Access Compliance Report

Public Rights-of-Way

Intersection ID: 23448	Main Street: SUMMERLIN_PL	Cross Street: WEIRTON_PL	Location: NE
ADA ID: F2EC7ECE25FC	Ramp Type: PerpDiag	Initial Pass/Fail: Fail	Overall Compliance: No
		Severity Score: 12.5

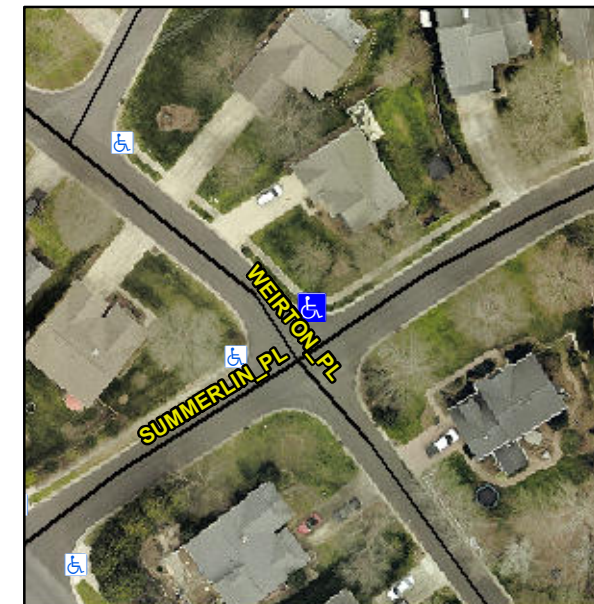
R304.2.2

Compliance	Description	Data	Compliance	Description	Data
N/A	Ramp Length (in)	43.0	No	Ramp Slope (%)	10.9
Yes	Ramp Width (in)	48.0	Yes	Ramp XSlope (%)	0.7
N/A	Flare Type LT	N/A	N/A	Flare Type RT	N/A
N/A	Flare Slope LT (%)	N/A	N/A	Flare Slope RT (%)	N/A
N/A	Flare Traversable LT?	N/A	N/A	Flare Traversable RT?	N/A
N/A	Landing Length (in)	N/A	N/A	DWS Provided?	N/A
N/A	Landing Width (in)	N/A	N/A	DWS Contrast?	N/A
N/A	Landing Slope (%)	N/A	N/A	DWS Length (in)	N/A
N/A	Landing X Slope (%)	N/A	N/A	DWS Full Width?	N/A
N/A	Landing Curb? (Y/N)	N/A	N/A	DWS Offset (in)	N/A
N/A	Shared Landing?	N/A			
N/A	Gutter Ponding?	N/A	N/A	Gutter Slope (%)	N/A
N/A	Gutter Lip Ht (in)	N/A	N/A	Gutter X Slope (%)	N/A
N/A	Painted X Walk1?	No	N/A	Painted X Walk2?	No
	X Walk 1 Direction	To W		X Walk 2 Direction	To SE
N/A	X Walk 1 Width (in)	N/A	N/A	X Walk 2 Width (in)	N/A
	X Walk 1 Slope (%)	2.0		X Walk 2 Slope (%)	5.4
	X Walk 1 X Slope (%)	4.2		X Walk 2 X Slope (%)	0.8

Remove & Replace Curb Ramp With Two New Directional Ramps or Equivalent.
